**City of Glendale
Community Development Department
Design Review Staff Report – Multi-Family**

Meeting/Decision Date: October 11, 2021	Address: 3419 Montrose Avenue
Review Authority: <input type="checkbox"/> DRB <input checked="" type="checkbox"/> ADR <input type="checkbox"/> HPC <input type="checkbox"/> CC	APN: 5607-004-032
Case Number: PDR2106786	Applicant: Helbert Moradian
Prepared By: Danny Manasserian, Planning Associate	Owner: Arbita Nersesian

The applicant is proposing to construct additions at the front and rear of the existing house, build a new two-story residential unit and garages behind the house, and demolish the existing garage. The property is located in the R-3050 (Moderate Density Residential) zone.

PROPOSED SOUTH ELEVATION
1/4"=1'-0"

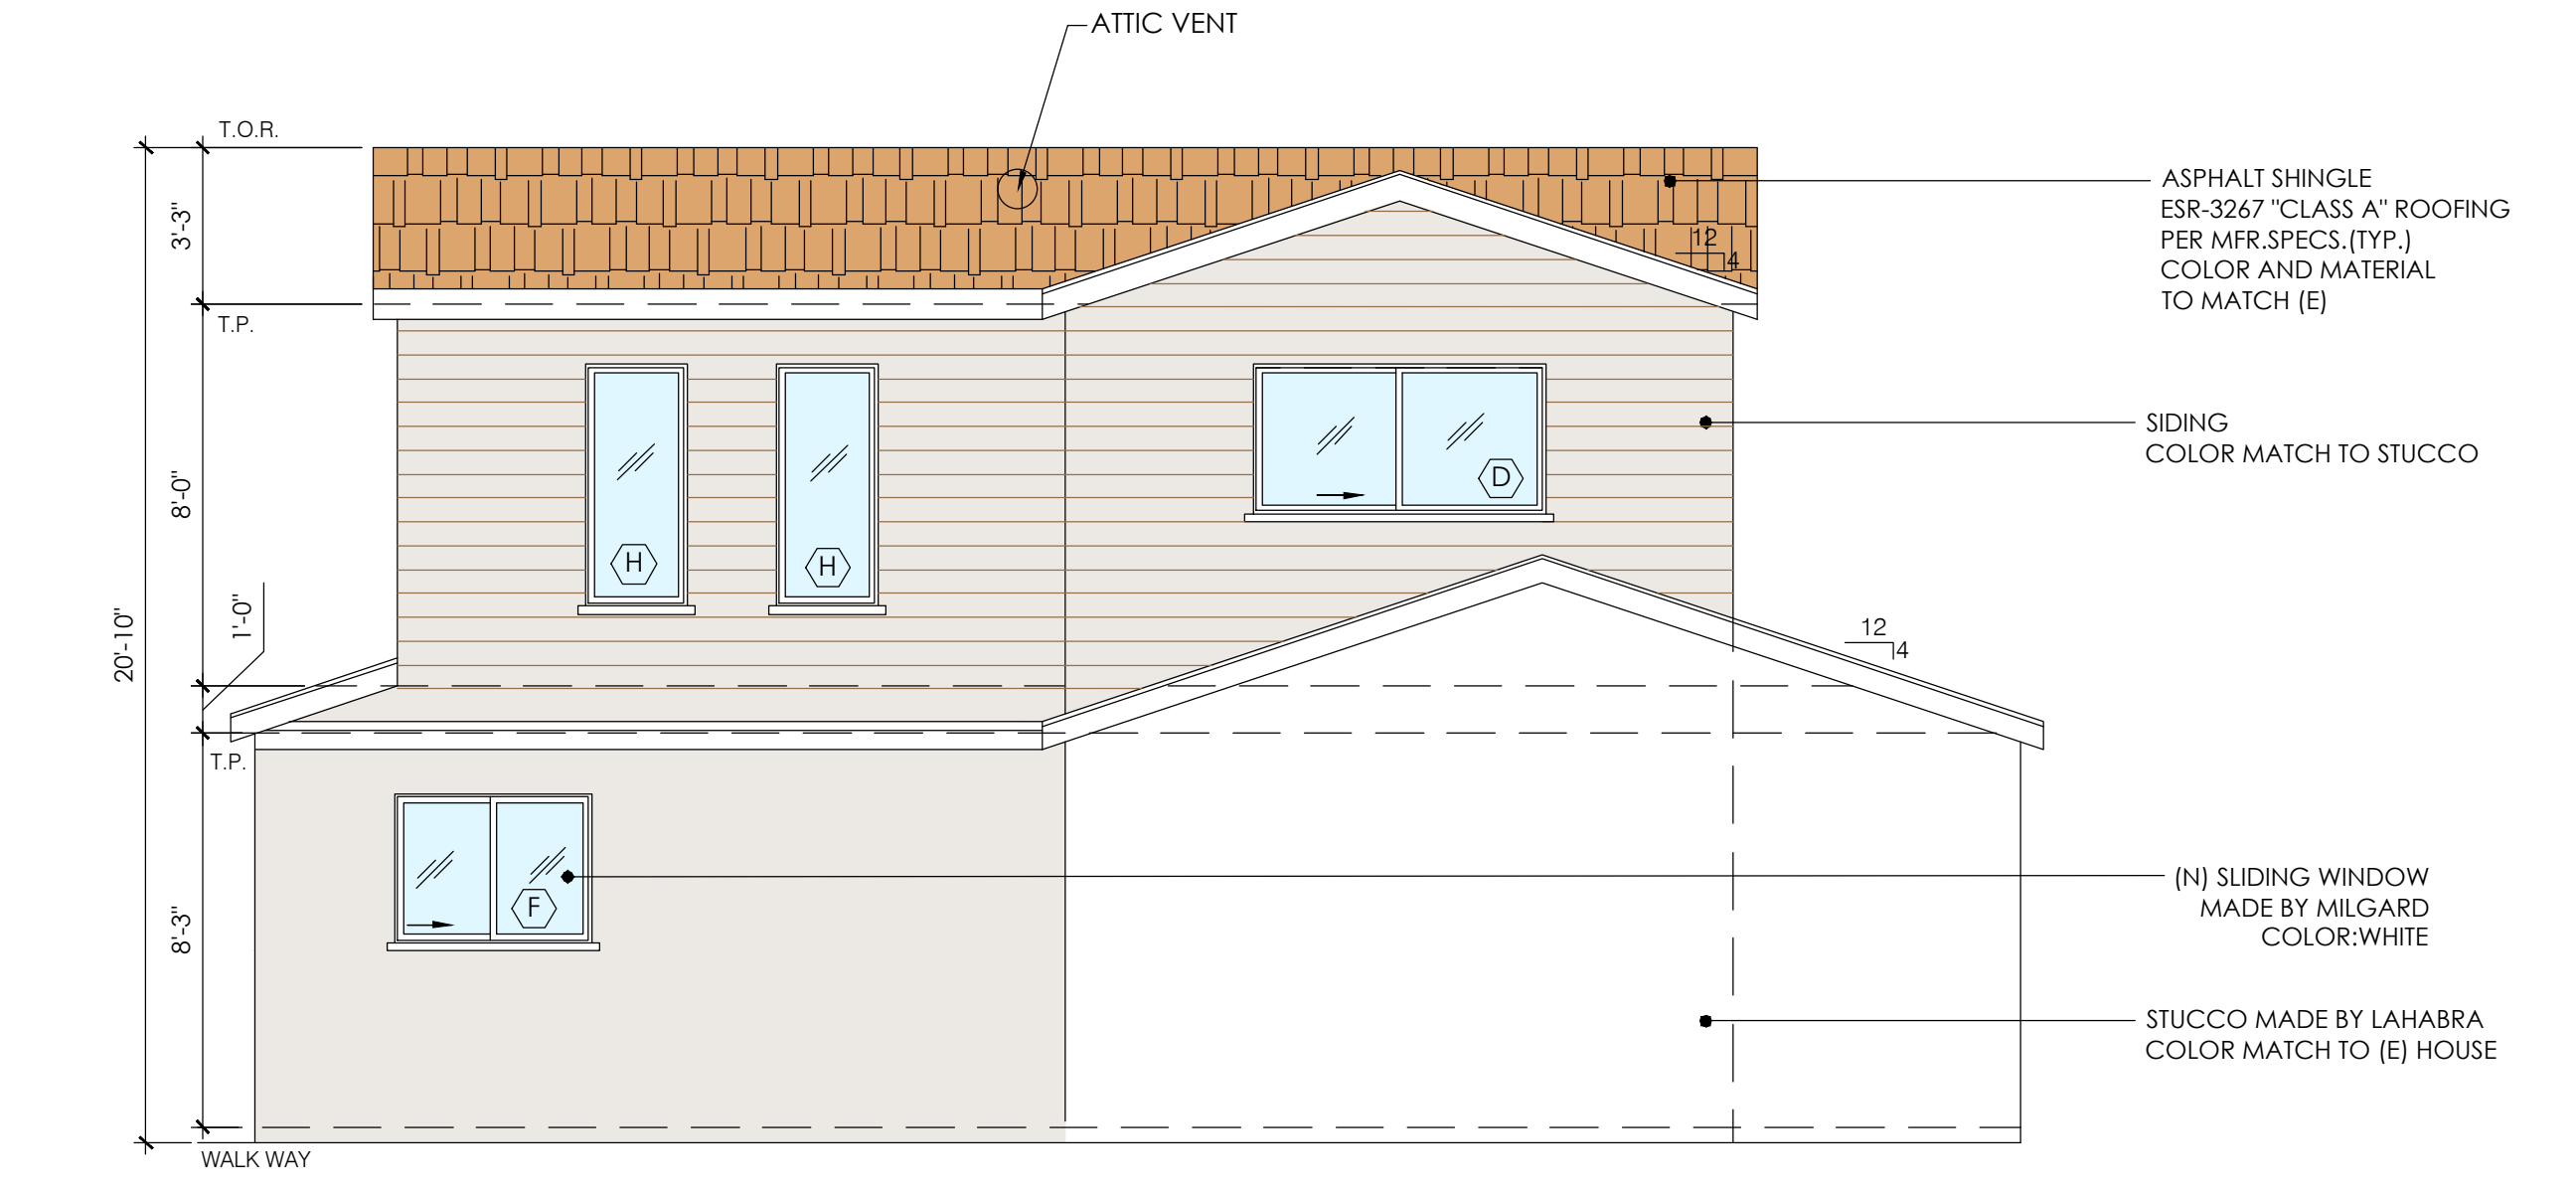
The design will be enhanced if the siding color is somewhat darker, rather than the same as, the color of the walls. A condition to this effect is added.

- The traditional design of the new unit is appropriate to the neighborhood and the existing house.
- The placement of the proposed cement fiber siding on the new unit is appropriate, however, as proposed, the color is the same as the stucco. A condition has been added to choose a somewhat darker color to complement the white stucco.
- All windows will be vinyl, recessed with a wood sill and frame to match the proposed windows on the front house. As proposed, the windows are appropriate to the design and the neighborhood in terms of their operation and overall appearance.
- The roof material includes brown composition shingle, matching the front house.

1. Propose somewhat darker color for cement fiber siding at new unit for staff review.
